WES-2024-6: Load assessment of a wind farm considering negative and positive yaw misalignment for wake steering

Author's Response to the Reviewers

Figure 1: Example of the convergence study on the radial discretization of the wake model within FAST.Farm done during the calibration phase.

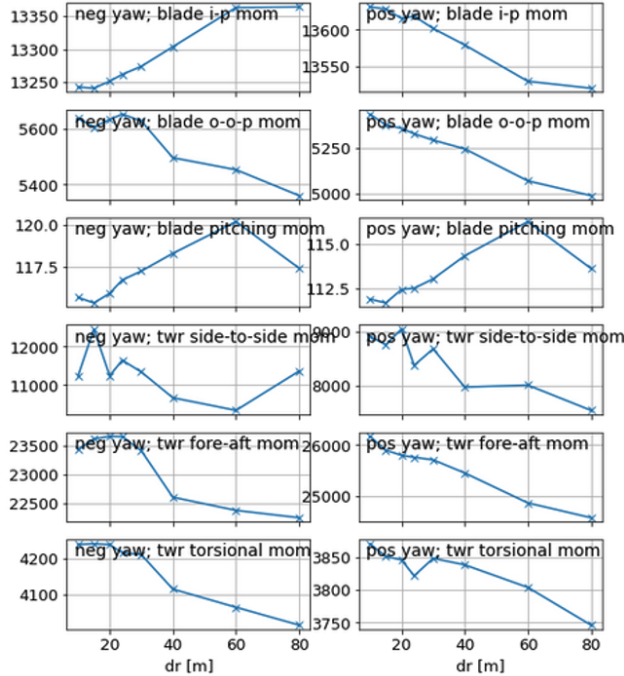
Reviewer Point P 1.4 — In addition, the calibration in Section 3 only reports metrics for the mean power production, what is the difference for the other load ‘channels’ analyzed in Sections 4 and 5? Why using the wake position for model calibration instead of the metrics used for the analysis and discussion?

Reply: The calibration process was more thorough than what we showed on the manuscript— we tried to avoid this section taking too much space when it’s not the focus of the paper. The wake center is used to ensure the parameters that control the wake deflection within the dynamic wake meandering model are consistent and agree well with LES. With the wake at the location matching the LES, we are likely to obtain the correct performance of the downstream, waked turbines and thus similar power, which is the quantity we match next. The calibrated parameters shown in Tables 2 and 3 are only related to the wake. Power and loads are consequences of the wake being (or not being) correct. Other tuning, not shown on the manuscript, was related to the radial discretization of the wake model. For that, we increased the number of points and, looking at the same load channels investigated in this work, noted convergence of their standard deviation values. Figure 1 shows part of that convergence exercise taken to ensure the discretization was appropriate for our problem. Similar convergence of the standard deviation values of the load channels were conducted during the calibration phase, but omitted in the article.
